CERTIFICATE OF APPROPRIATENESS

Property: 806 Branard, TRS 3 4A & 5A Block 19, Lockhart Connor & Barziza, Harris

Significance: Contributing craftsman style bungalow, constructed circa 1920, located in

Figure 3 - Staff Photo July 2021-front South facing elevation

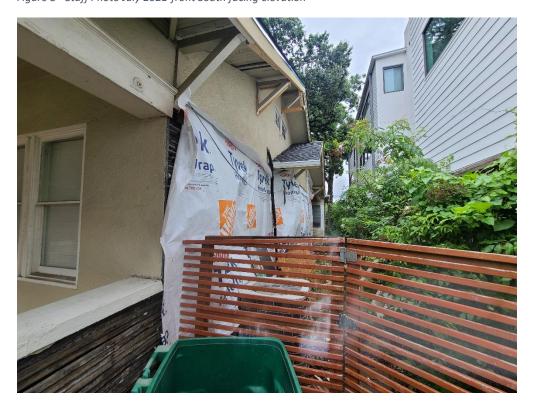
Recommendation: Denial of COA and issuance of a COR to replace the siding removed with stucco with a

dash finish to match the original texture and the restoration of the original wooden

windows.
